The Courts at Birch Meadow

Stamford, Connecticut

Environmental Review Team Report

**Prepared by the
King's Mark Environmental Review Team
of the King's Mark
Resource Conservation and Development Area, Inc.**

Figure 6 - House to be removed according to proposal.

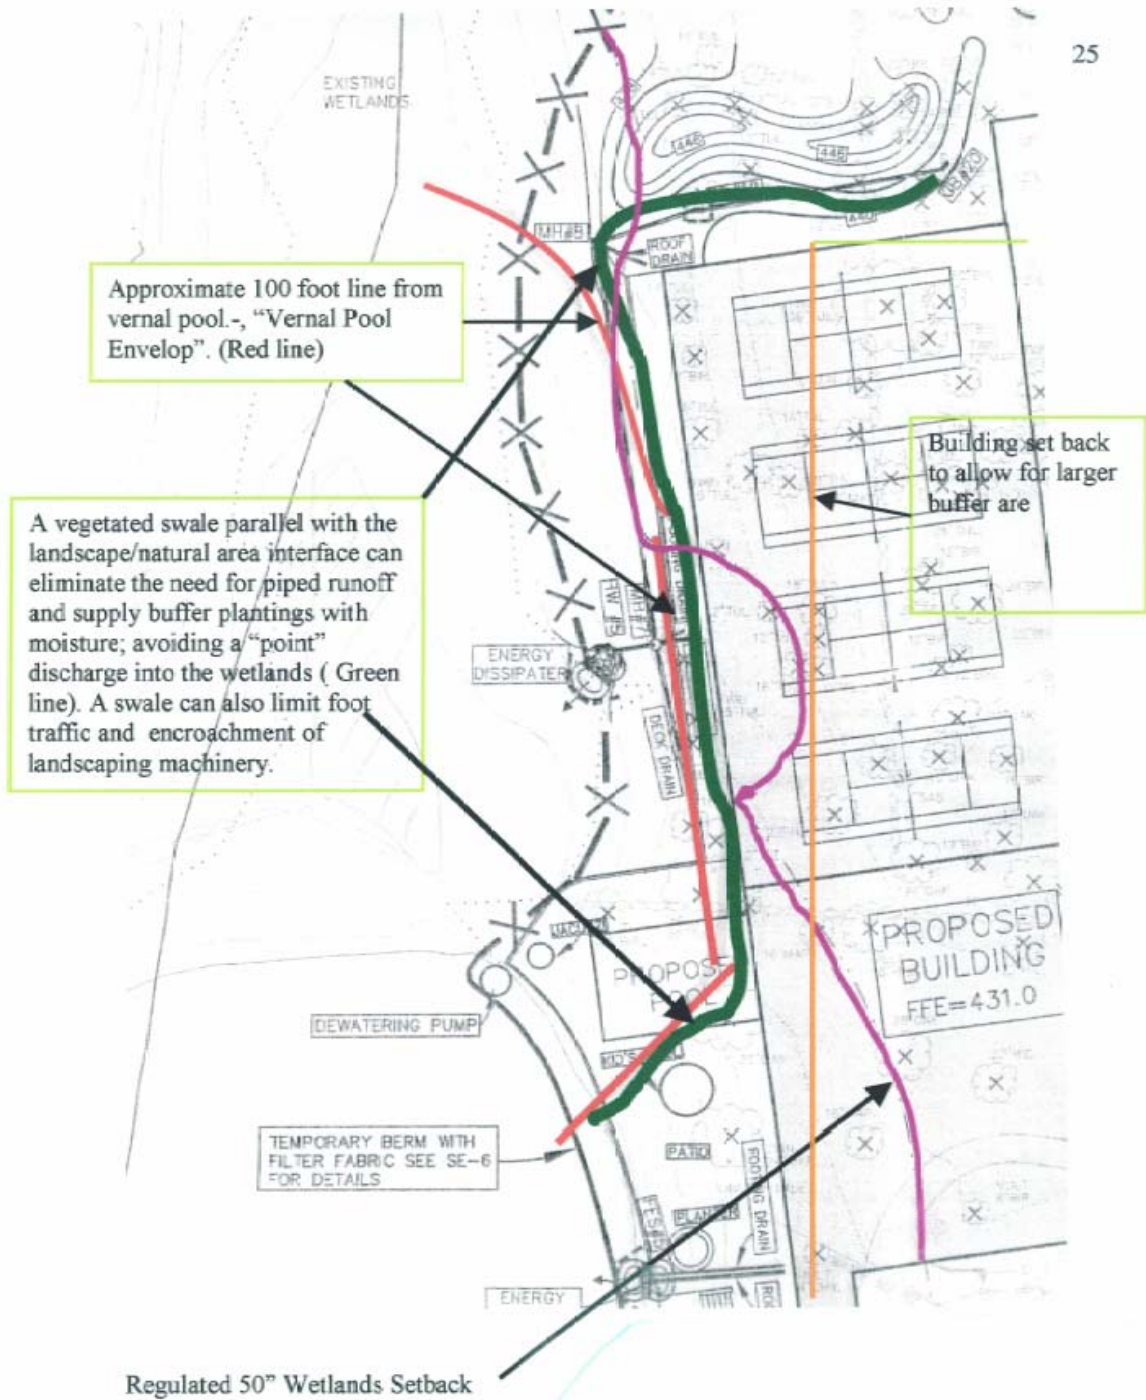
One of the houses is slated for unspecified removal as part of this project. (See Figure 6). Current constraints on construction and demolition waste disposal, the developing used building materials market and the recently developed building deconstruction businesses (some of whom will provide a cost estimate for a complete deconstruction process) now provide an opportunity to save 80-95% of the materials of a structure. The environmental and economic implications of this alternative to typical demolition are far reaching and indirectly effect soil and water conservation on a large scale. A cost benefit analysis that considers a basic option protocol is warranted. Deconstruction, particularly on older buildings in good condition, is now often less expensive than typical demolition.

Figure 7 - Suggested Buffer at Wetlands O

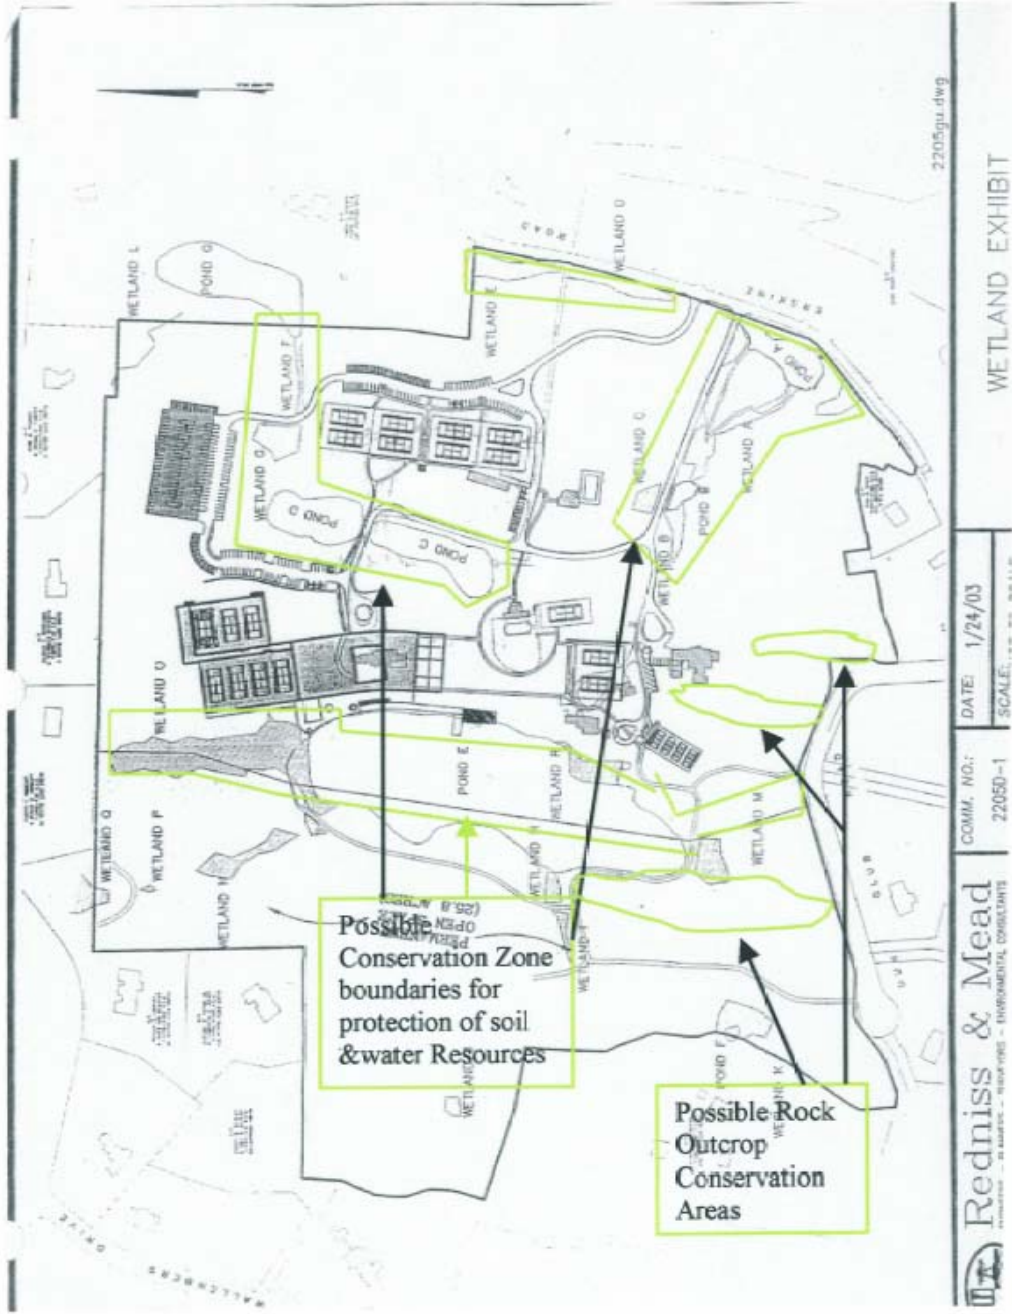
- Maintain a 100 foot buffer for a "Vernal Pool Envelop" (Calhoun & Klemens,2002), adjacent to the Vernal Pool in wetlands O (See Figure 8). The buffer should not only include vegetation as a buffer for erosion prevention and light pollution, but also to inhibit intrusion of pedestrian traffic, litter and the like. A dense line of vegetation in conjunction with a stone wall, rail fence or swale could be used. Management recommendations from Calhoun & Klemens Best Development Practices, for a Vernal Pool Envelop are:

Figure 10 - Depressed Parking Lot Island Concept

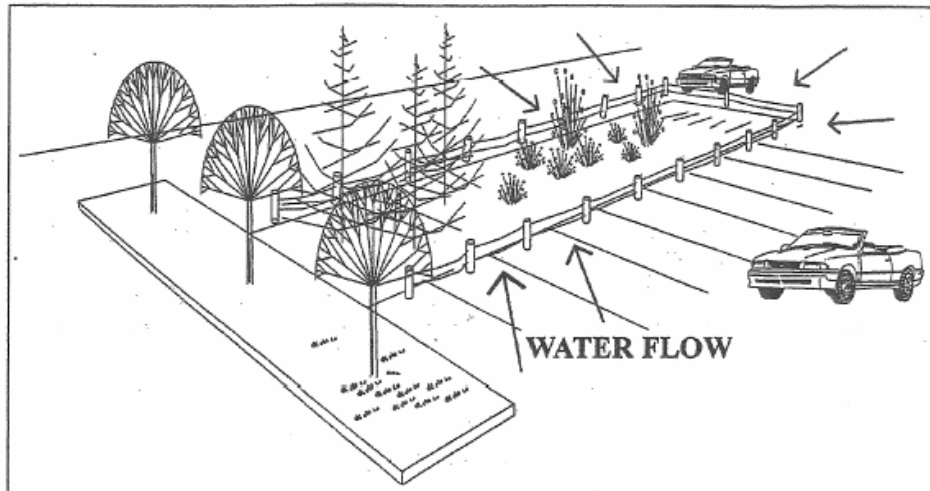
(See Figures 5, 9, 10, 11 and 12). By eliminating curbing and allowing for sheet flow of runoff to vegetated areas, the storm water runoff then contributes to vegetation growth instead of being conveyed towards a single point and then off the site. It is also possible to connect islands with overflows to, in effect, create a multi-cell infiltration and pollution mitigation system. Using light colored material to minimize heat absorption. (See Figure 9).
